CARTRIDGE TAPE DRIVES
TABLE OF CONTENTS

CUSTOMER ENGINEERING
SERVICE HANDBOOK

CARTRIDGE TAPE DRIVES

MODELS: 2229
2529
6529

210-8260
R1
ECO 39188

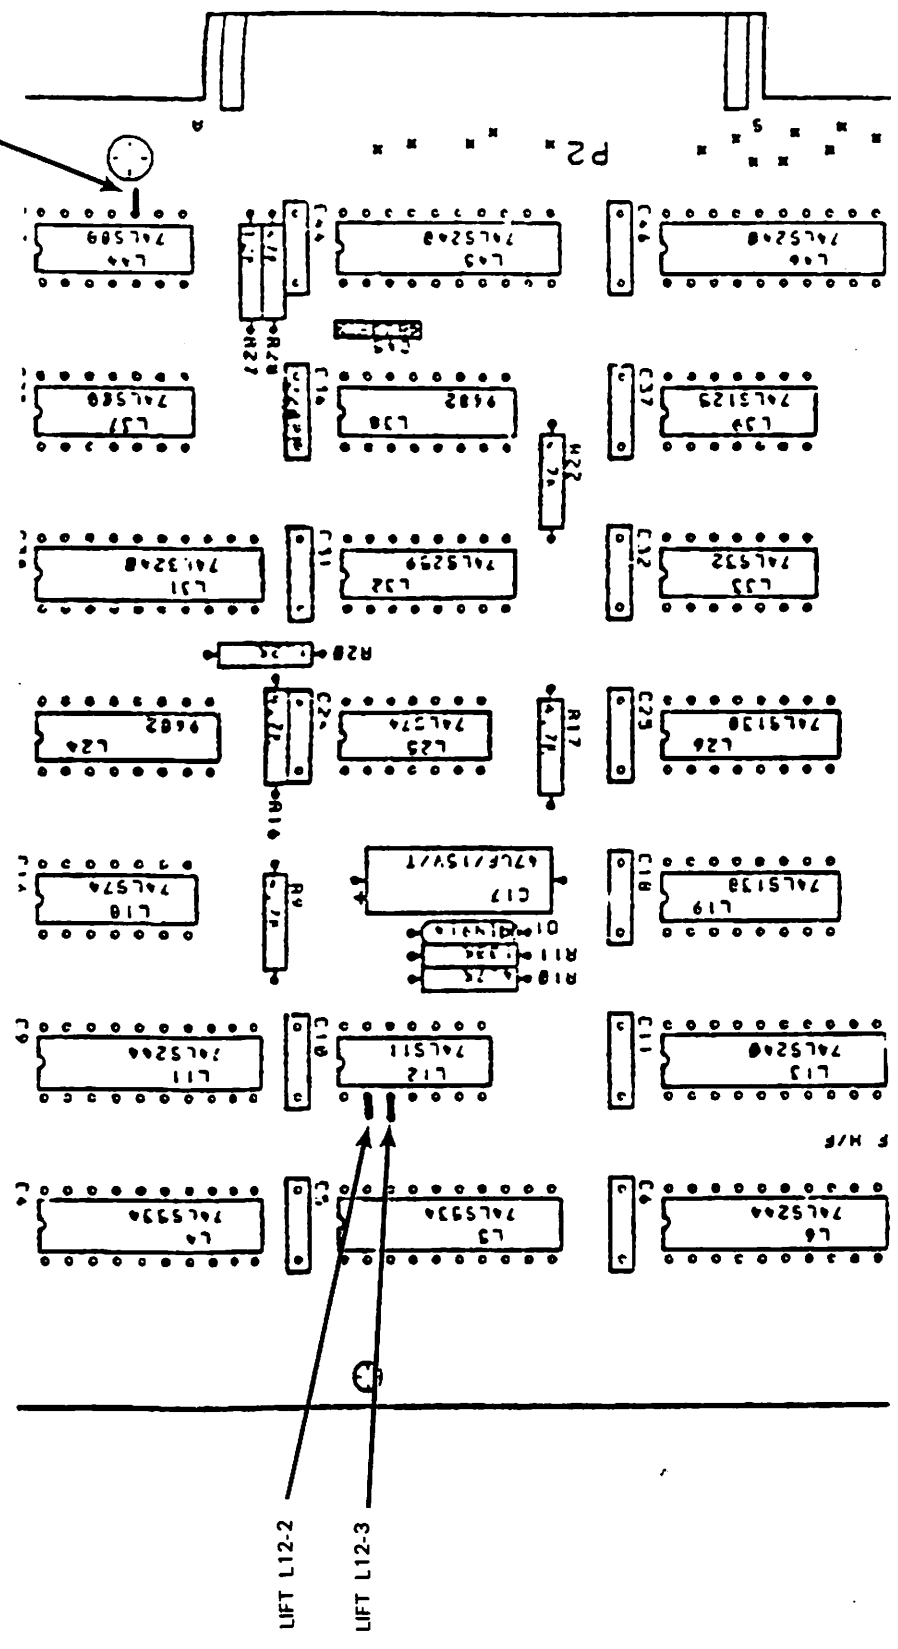
LIFT L44-10

JUMPER L46-20 TO
L47-14 TO 10K OHM
RES. AS SHOWN

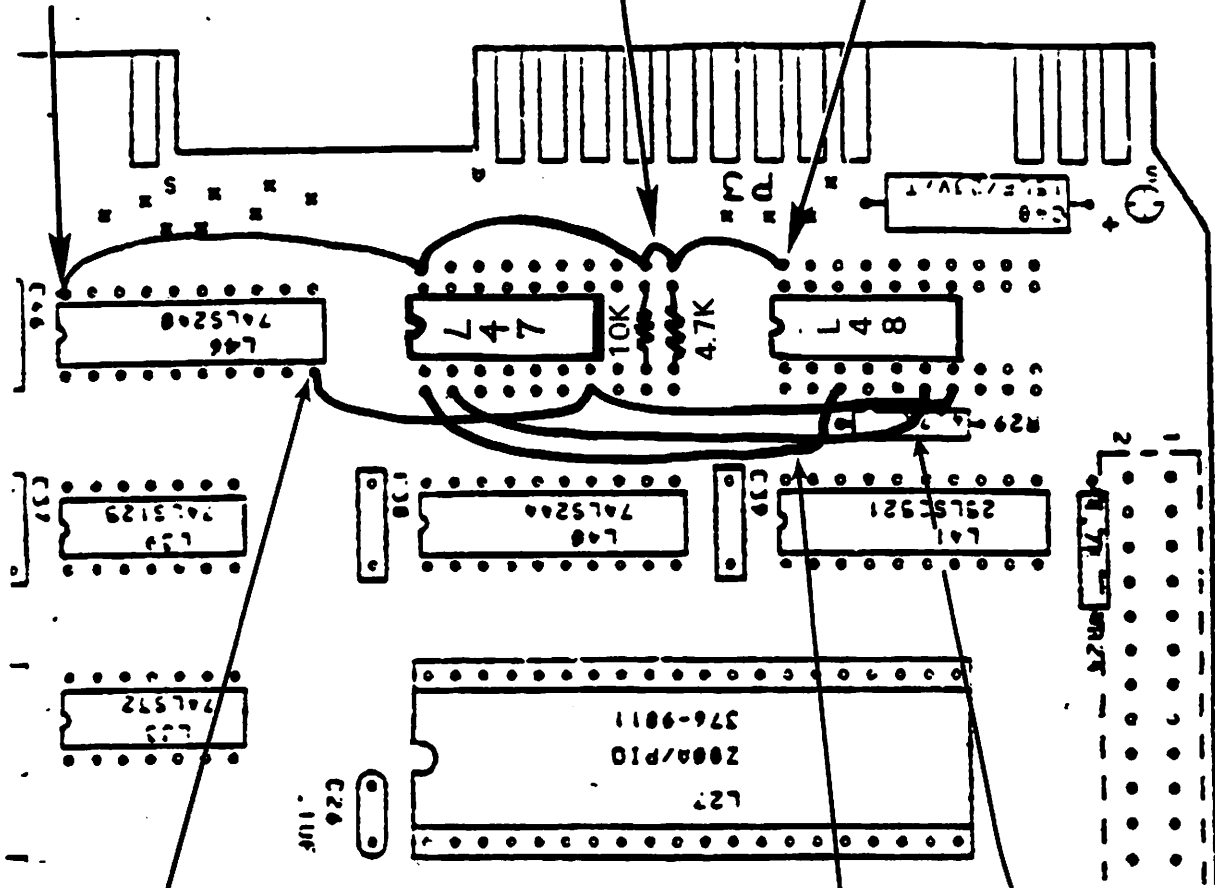
BUSS 10K OHM RES
TO 4.7K OHM RES.
AS SHOWN

JUMPER L48-14 TO
4.7K OHM RES

ACTD POWER SUPPLY PCB
WLI NO. 210-7770

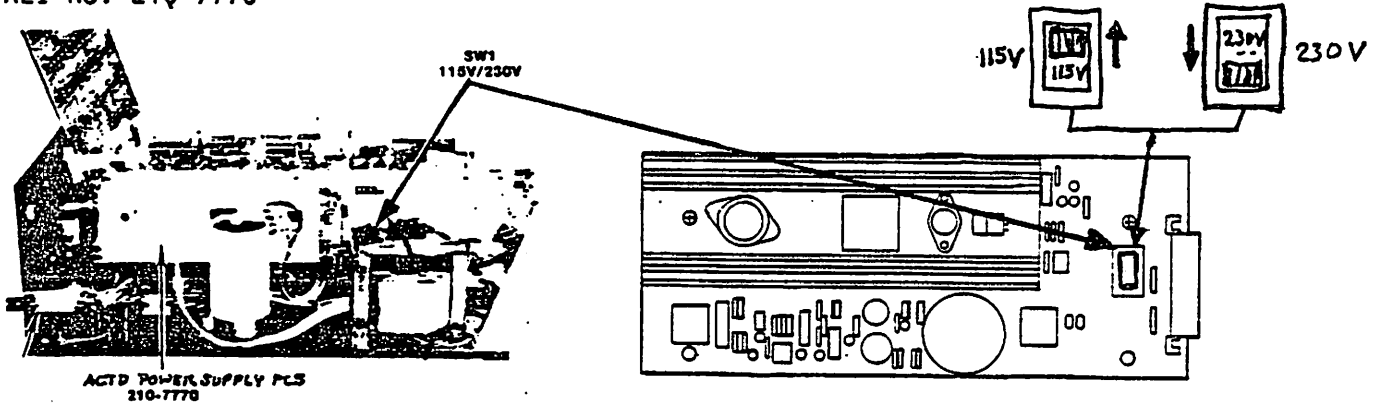
*Provide Pictures
and test point
"Camera Ready"*

TITLE: IMPROPERLY WIRED 2229 TAPE CONTROLLERS

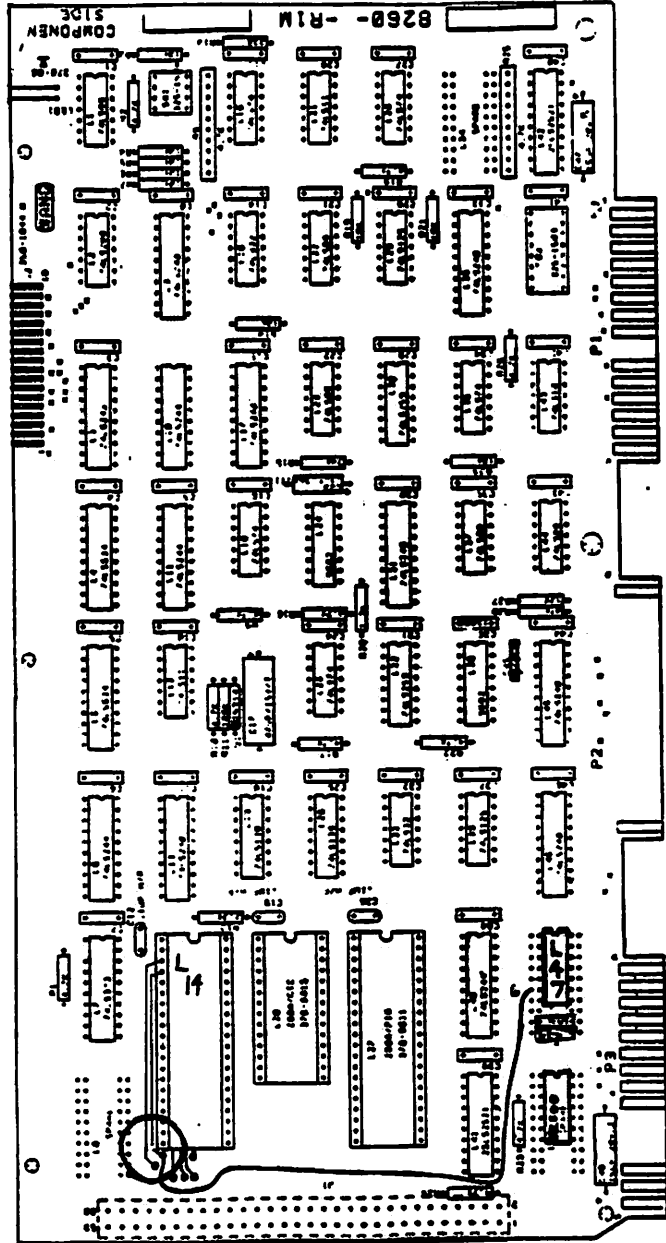
Using an OHM meter verify that the 8260 board agrees with the 3 steps listed below.

The controller may be incorrectly wired on either side of the 8260 board and therefore an OHM meter must be used! After the jumper has been moved to the correct location, check by using the 3 steps listed above.

proper location
of cut etch and
jumper
